Access Compliance Report

Public Rights-of-Way

(Curb Ramps)

Intersection ID: 47810	Main Street: NEVIN_GLEN_DR	Cross Street: GRAYPARK_DR	Location: SE
ADA ID: A0F637DADFBA	Ramp Type: PerpDiag	Initial Pass/Fail: Fail	Overall Compliance: No
Codes/Mitigation Info/Possible Solution		Field Measurements/Component Compliance	
Severity Score: 36.25

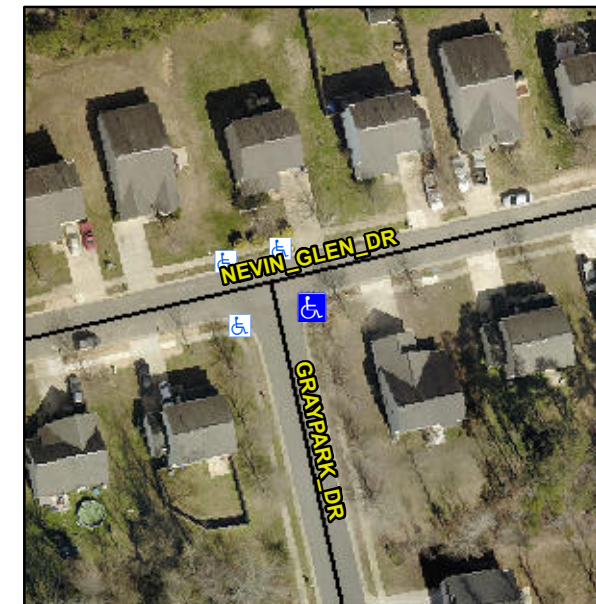
Not Found, R304.5.1, R304.5.3, R302.7

Compliance	Description	Data	Compliance	Description	Data
N/A	Ramp Length (in)	49.0	Yes	Ramp Slope (%)	6.2
No	Ramp Width (in)	36.5	No	Ramp XSlope (%)	5.7
N/A	Flare Type LT	N/A	N/A	Flare Type RT	N/A
N/A	Flare Slope LT (%)	N/A	N/A	Flare Slope RT (%)	N/A
N/A	Flare Traversable LT?	N/A	N/A	Flare Traversable RT?	N/A
N/A	Landing Length (in)	N/A	N/A	DWS Provided?	N/A
N/A	Landing Width (in)	N/A	N/A	DWS Contrast?	N/A
N/A	Landing Slope (%)	N/A	N/A	DWS Length (in)	N/A
N/A	Landing X Slope (%)	N/A	N/A	DWS Full Width?	N/A
N/A	Landing Curb? (Y/N)	N/A	N/A	DWS Offset (in)	N/A
N/A	Shared Landing?	N/A			
N/A	Gutter Ponding?	N/A	N/A	Gutter Slope (%)	N/A
N/A	Gutter Lip Ht (in)	1.0	N/A	Gutter X Slope (%)	N/A
N/A	Painted X Walk1?	No	N/A	Painted X Walk2?	No
	X Walk 1 Direction	To N		X Walk 2 Direction	To W
N/A	X Walk 1 Width (in)	N/A	N/A	X Walk 2 Width (in)	N/A
	X Walk 1 Slope (%)	8.0		X Walk 2 Slope (%)	1.0
	X Walk 1 X Slope (%)	4.2		X Walk 2 X Slope (%)	4.9

N/A	Ramp inside XWalk1?	N/A	N/A	Ramp inside XWalk2?	N/A
	Road Slope (%)	6.4	N/A	Clear Space?	N/A
	Road X Slope (%)	3.2	N/A	Clear Space to XWalk (in)	N/A
N/A	Any Obstructions?	N/A	N/A	Storm Grate/Utility Hazard?	N/A
	Obstruction Type			Storm Grate/Utility Type	
		N/A			N/A
		No		Surface Condition? (G/P)	Poor

Remove & Replace Curb Ramp With Two New Directional Ramps or Equivalent.
